MAYFLOWER PLATINUM

Details of Additions & Alterations

Flat No	407	Block no.	'A'
Flat Area	1800 sft	Type	Deluxe / Luxury
Buyer Name	Pulakanti Mohan Rao/ Rama Devi		
Phone No.	9949595509/ 9866171777	Email	pulakanti.mohan.e@gmail.com

Description	Direction	Owners & Developers :	Date :	18.03.2020	Promoted by
WORKING DRAWING OF FLAT.NO.A-7		Modi Properties Pvt Ltd.	Prepared By :		Modi Properties Pvt. Ltd Phone:+91-40-66335551
		Project Name & Phase :	Approved By :	Soham Modi	
		MAYFLOWR PLATINUM	Scale :	N.T.S

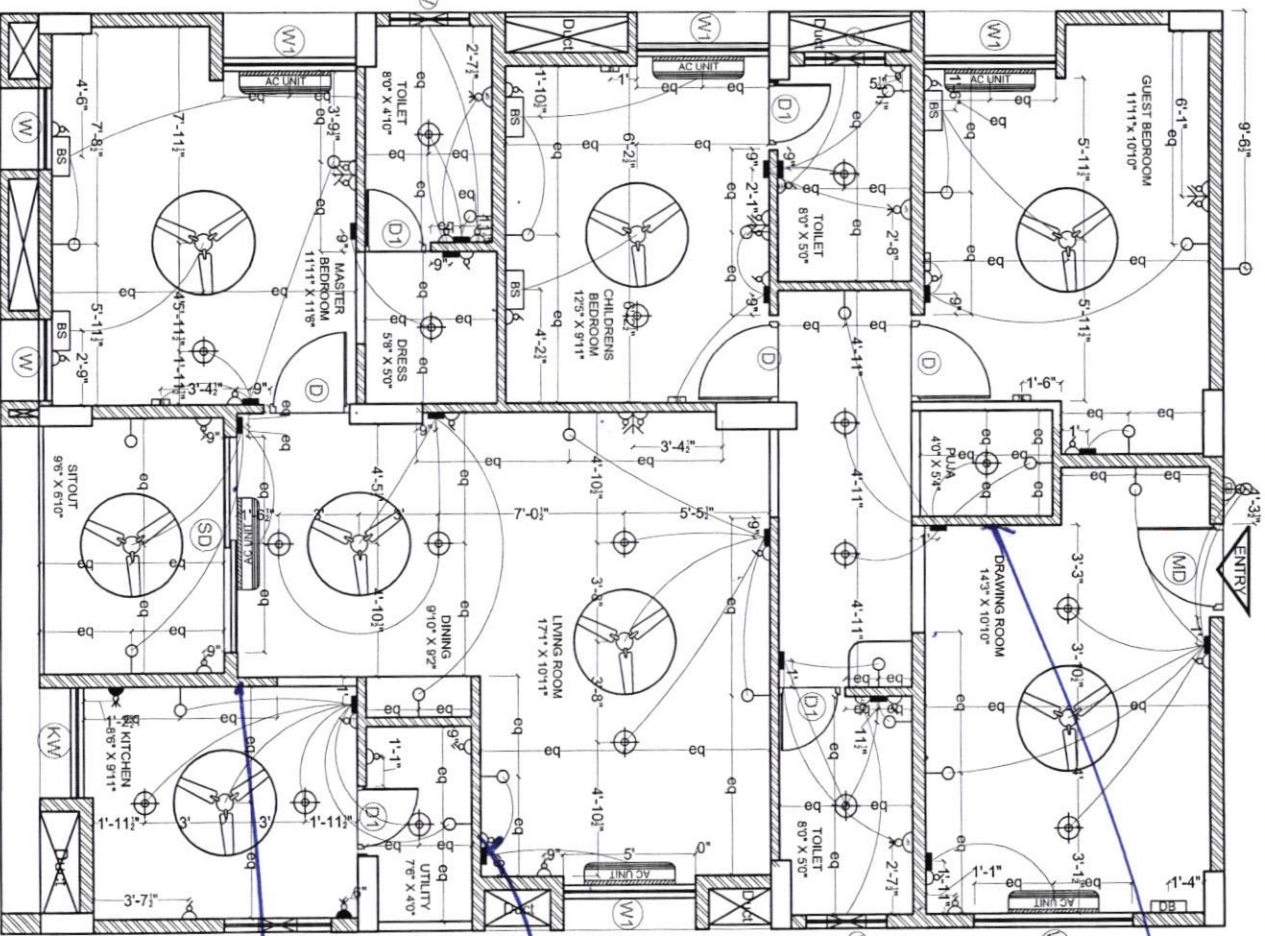
Other Changes: ① wall to be removed between
drawing & living.

have to be removed

ELECTRICAL PLAN OF FLAT-A7

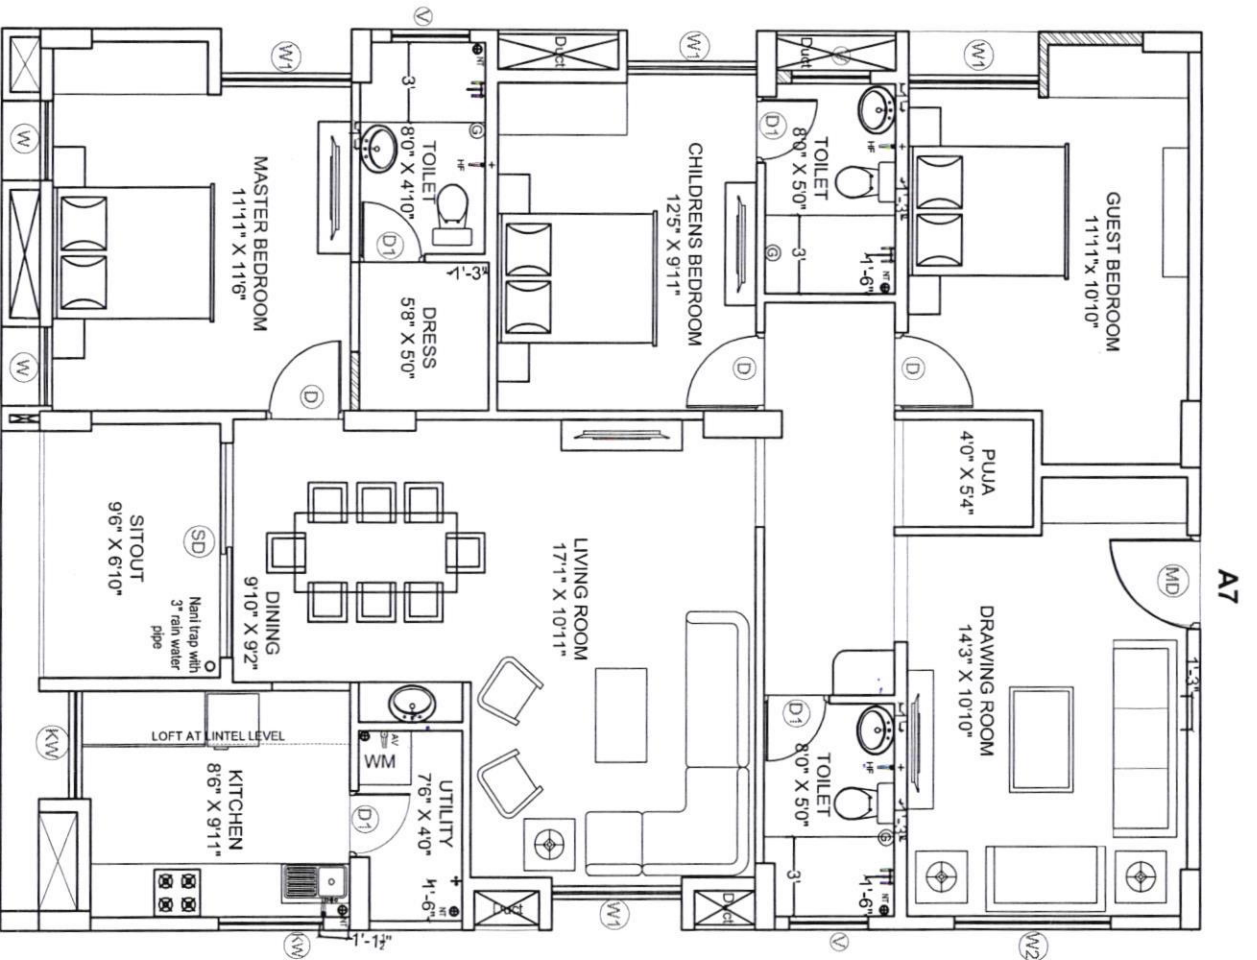
Changes in electrical points: (mark on plan)

① marked on plan

15amp for AC unit
15amp for AC unit
15amp for AC unit

15amp for AC unit
15amp for AC unit
15amp for AC unit
